ORDINANCE NO. 9340-19

AN ORDINANCE OF THE CITY OF CLEARWATER, FLORIDA MAKING AMENDMENTS TO BEACH BY DESIGN: A PRELIMINARY DESIGN FOR CLEARWATER BEACH AND DESIGN GUIDELINES; BY AMENDING SECTION VIII. APPENDIX B. "CLEARWATER MARINA DISTRICT BOARDWALK DESIGN GUIDELINES AND SPECIFICIATIONS" TO UPDATE THE STANDARDS TO WHICH THE PUBLIC BOARDWALK MUST COMPLY; BY AMENDING THE TABLE OF CONTENTS TO UPDATE THE EFFECTIVE DATE REFERENCED FOR THE GUIDELINES; AND PROVIDING AN EFFECTIVE DATE.

Clearwater Marina District Boardwalk Design Guidelines and Specifications

Figure 2
EAST SHORE DRIVE SIDEWALK SECTION DIAGRAM
 SCALE: 1/16"=1'-0"

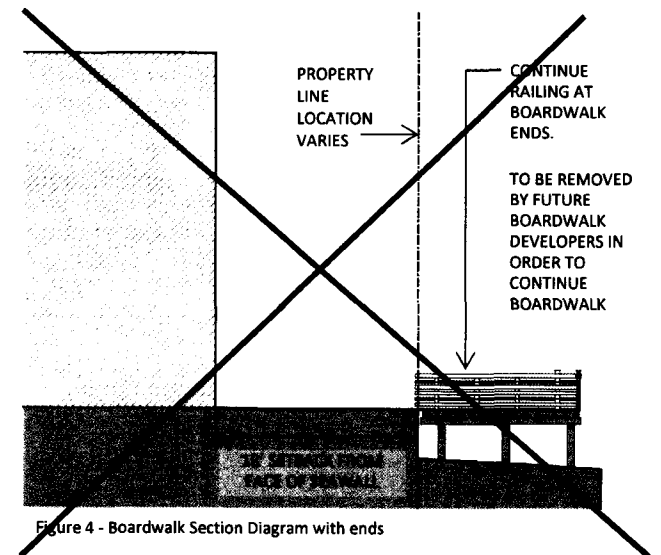
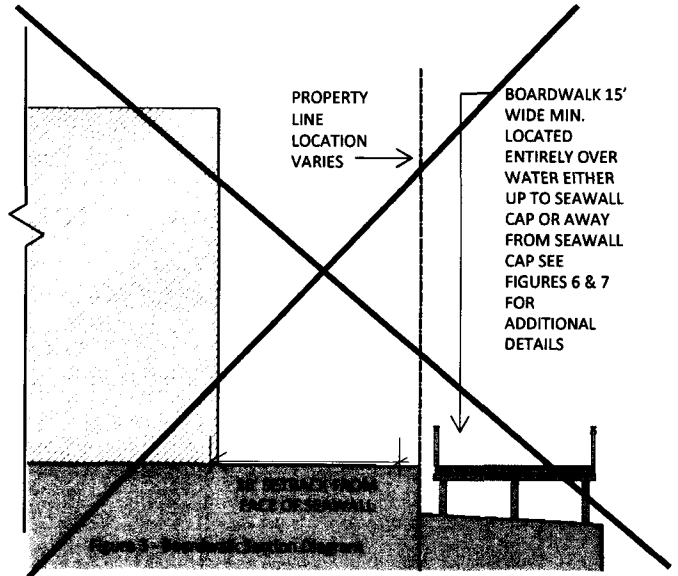
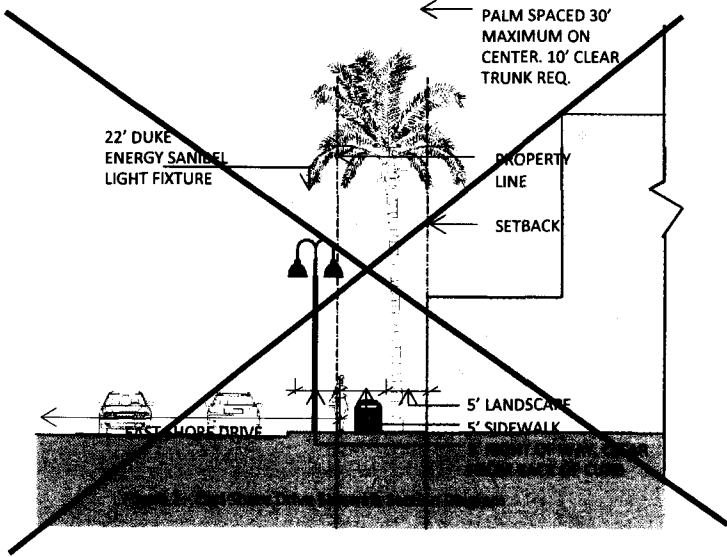
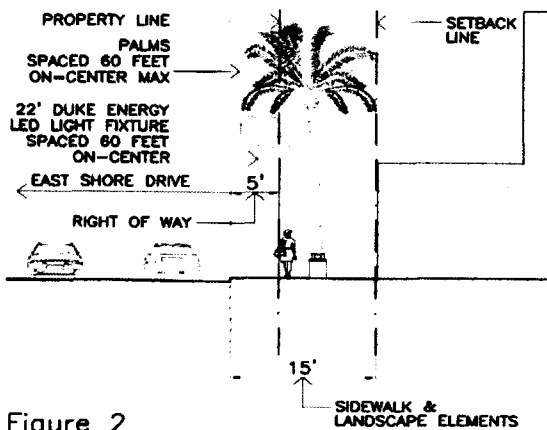
Remove existing Figures 2-4 and replace with the following Figures 2-4:

As shown in Figure 1 & 2 and as stated within the Beach by Design guidelines, a 10 15 foot wide (clear and starting from the street curb) clear setback, starting from the street curb, with a minimum 6 foot wide pedestrian sidewalk shall be provided along East Shore Drive shall be provided. An easement shall be required as necessary to provide this distance. The 15-foot wide setback from street curb to property line shall contain the following sidewalk improvements shall be provided, including, street lighting, trash receptacles, benches, landscaping, & and hardscaping material. All improvements shall not interrupt pedestrian movement along the sidewalk.

Mostdependablefountains.com, 10145 SMSS Chrome, at entry nodes

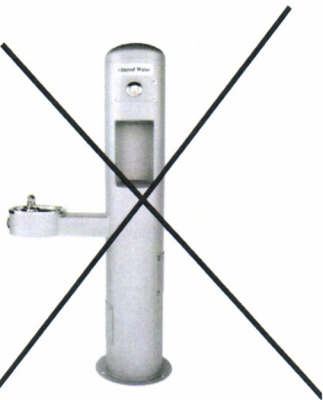
Remove existing graphic and replace with the following graphic

Mostdependablefountains.com, 10135 SMSS Chrome, for use at entry nodes

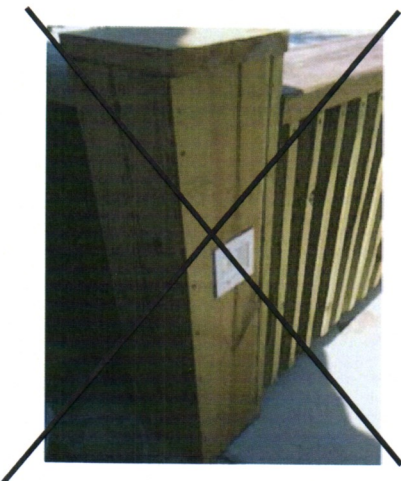
Remove existing graphic and replace with the following graphic:

~~Bright Ideas Shop, Trash Receptacle FP6095-P, for use at sidewalks, entry nodes, & at boardwalk~~

Trash Receptacle provided by the City of Clearwater Parks and Recreation Department

BOARDWALK SECTION AT SEA WALL

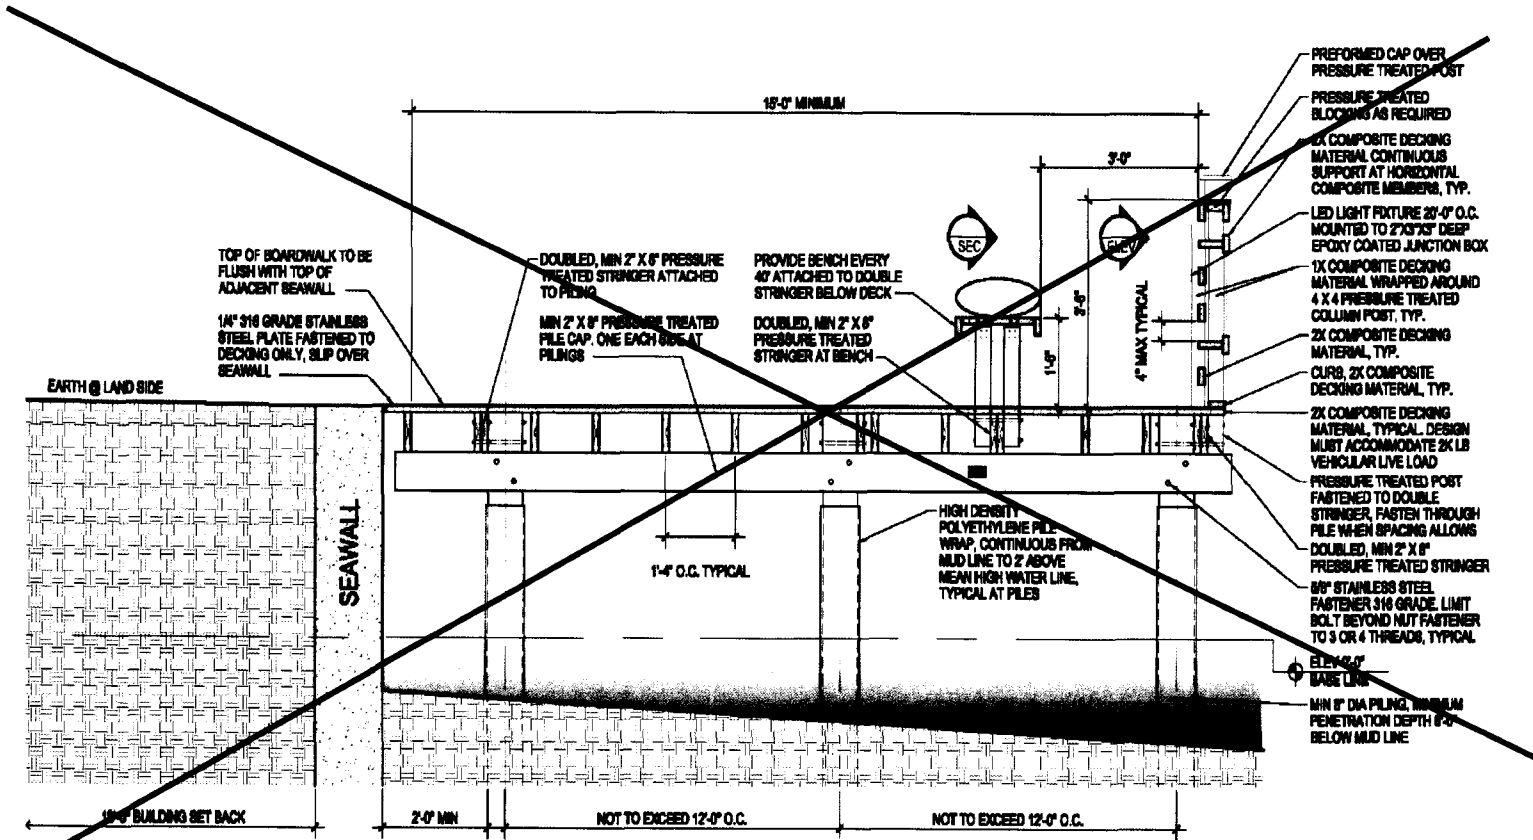
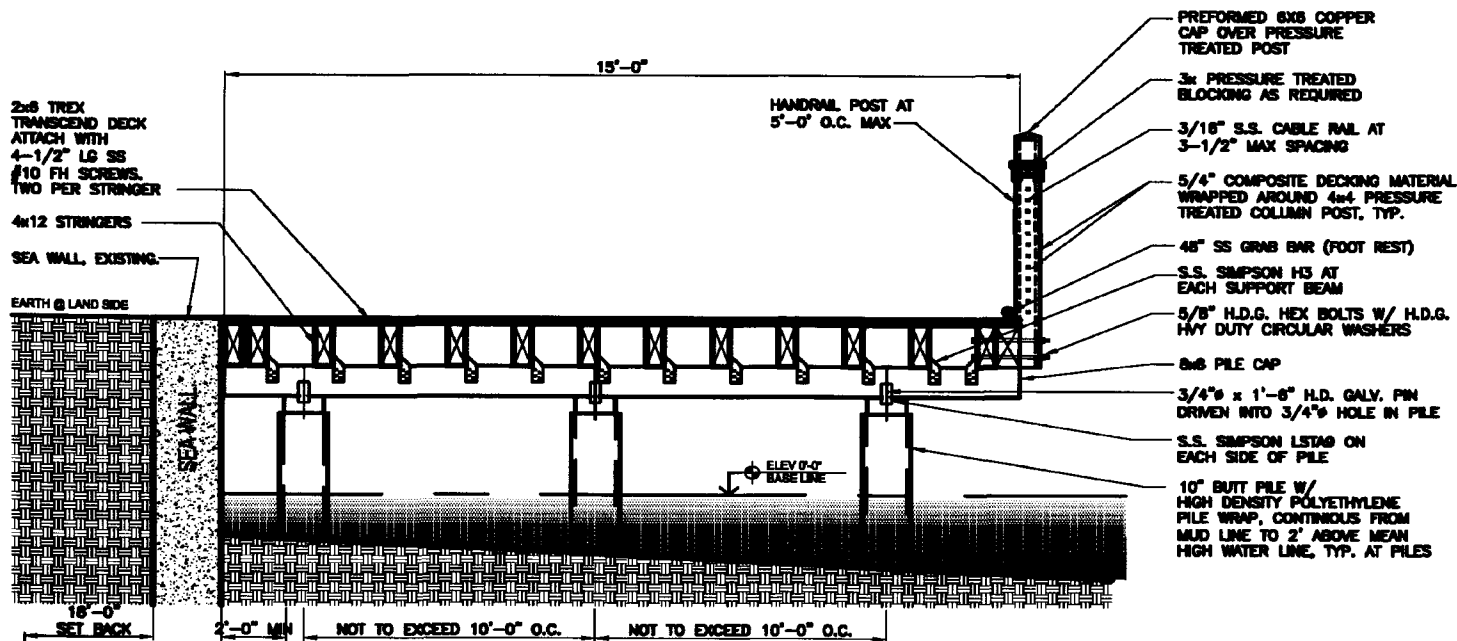
Remove existing Figure 6 and replace with the following Figure 6:

Detail indicates when boardwalk engages seawall providing continuous walkway

NOTE:
BOARDWALK SHALL NOT BE CONNECTED TO SEAWALL.

Figure 5
BOARDWALK SECTION
 SCALE: 1/4"=1'-0"

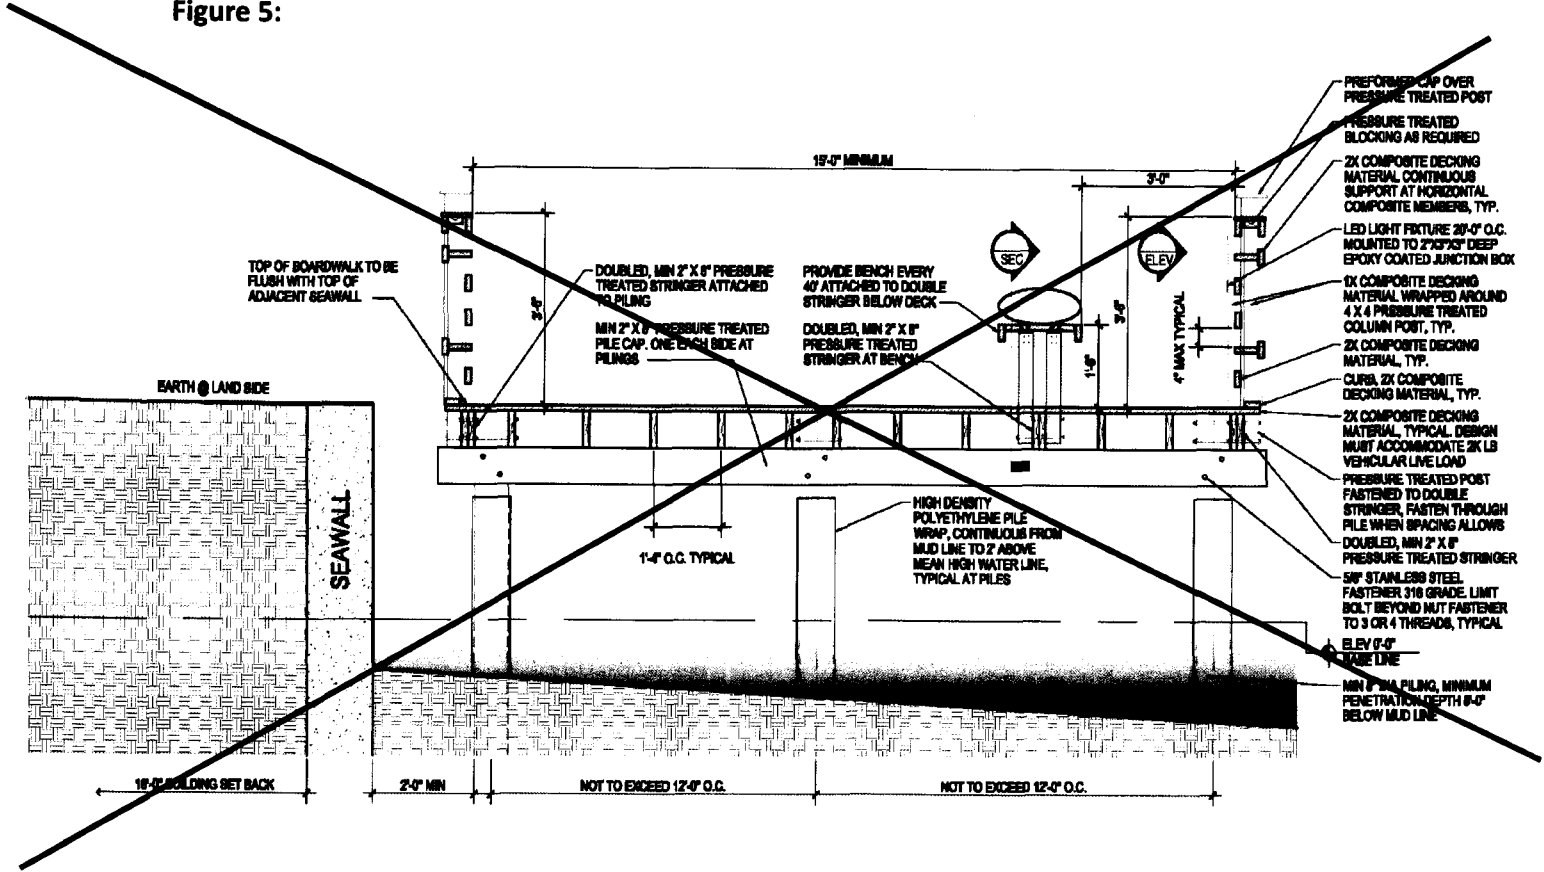
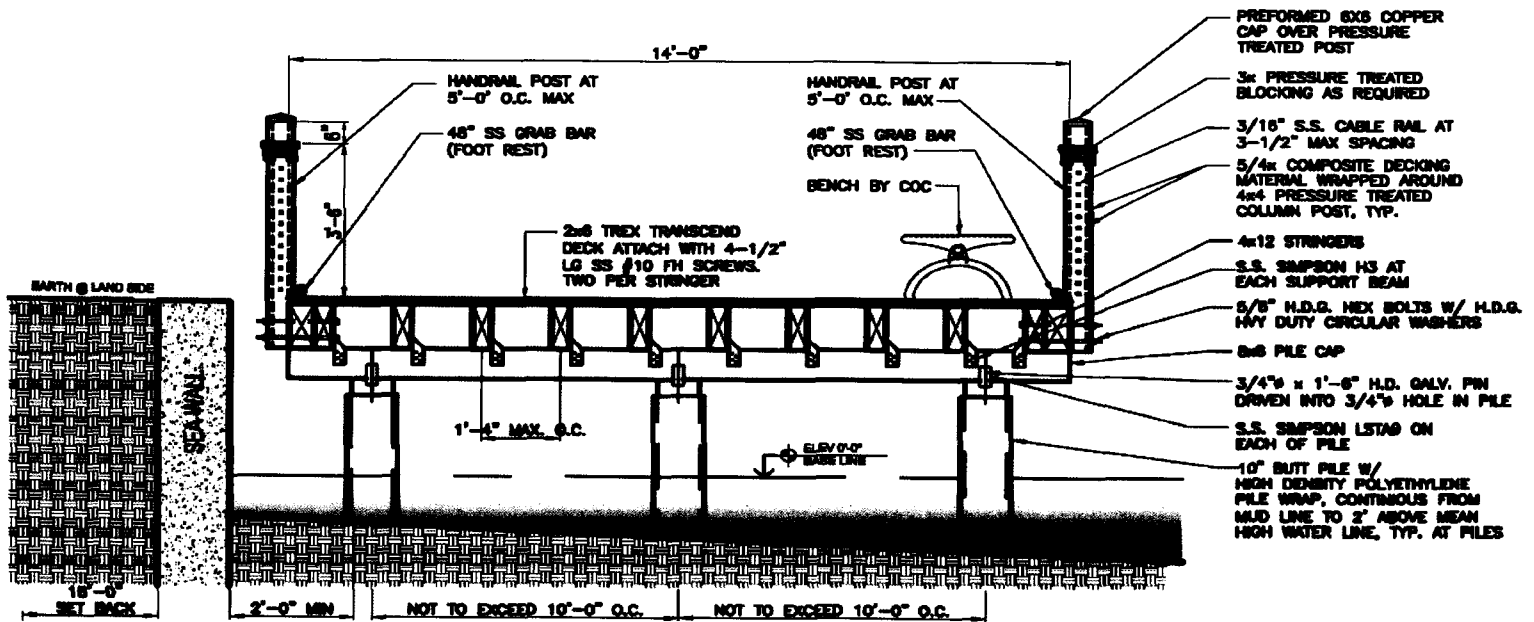
Remove existing Figure 7 and replace with the following figure, renumbered and relocated to Figure 5:

Figure 7 — Typical Boardwalk Section at 1/2" = 1'-0" Scale
 ——— Detail indicates when boardwalk is separated from seawall requiring railing at each side

NOTE:
 ALL PILING AND LUMBER TO BE PRESSURE TREATED SOUTHERN YELLOW PINE UNLESS OTHERWISE NOTED.

Figure 7
INTERIOR RAILING ELEVATION
 SCALE: 1/4" = 1'-0"
 NOTE:
 FASTEN HORIZONTAL RAILING
 USING STAINLESS STEEL
 HARDWARE

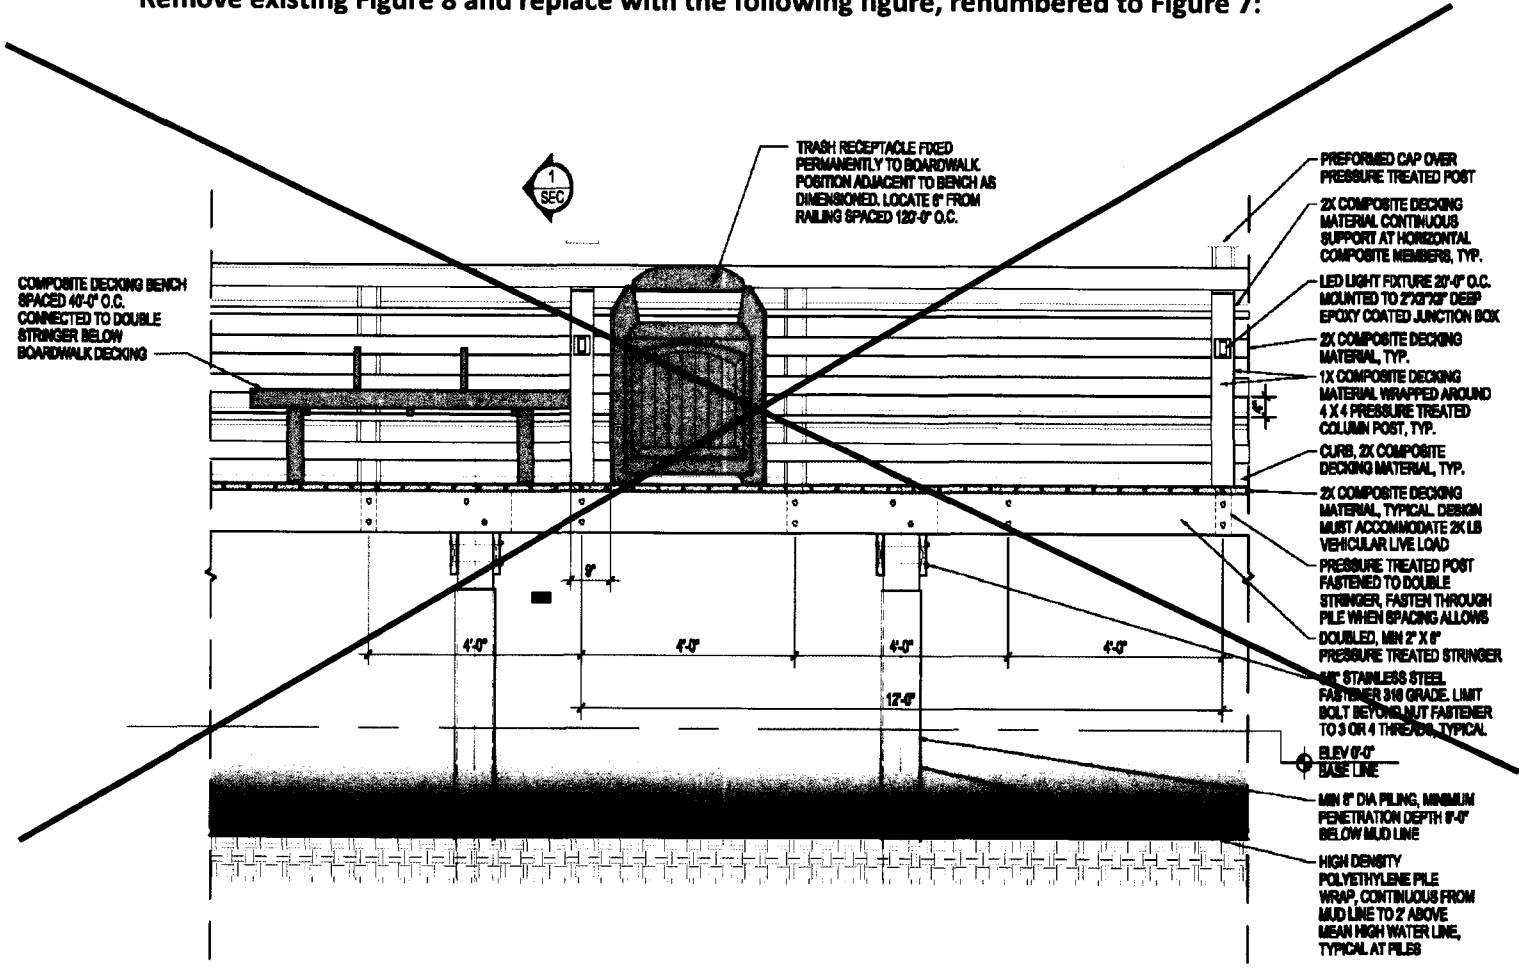
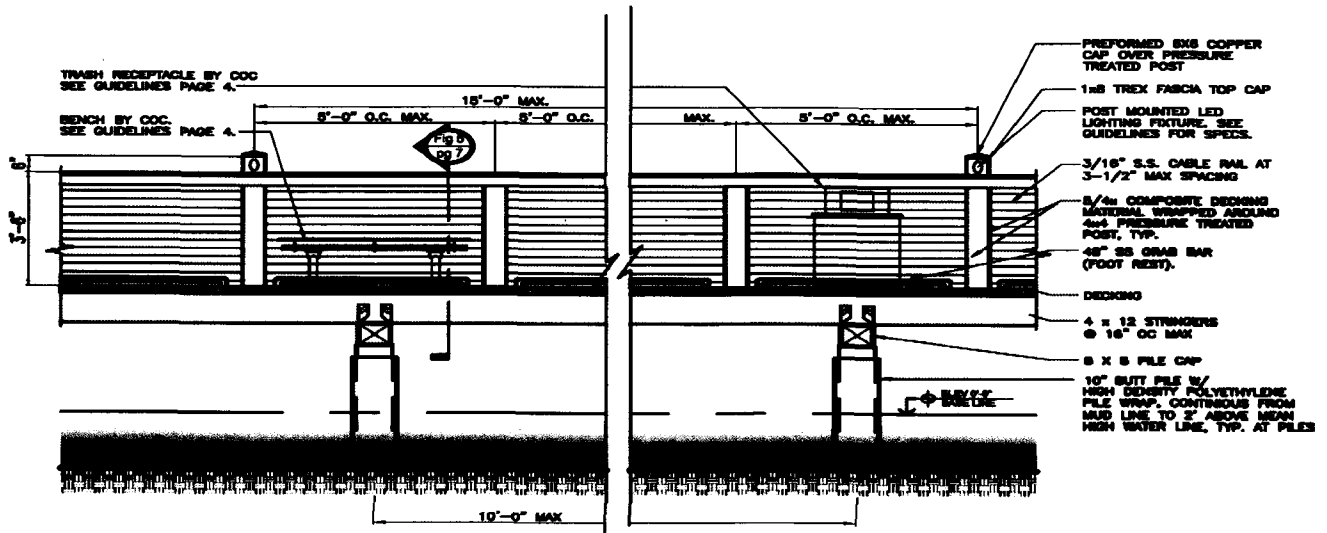
Remove existing Figure 8 and replace with the following figure, renumbered to Figure 7:
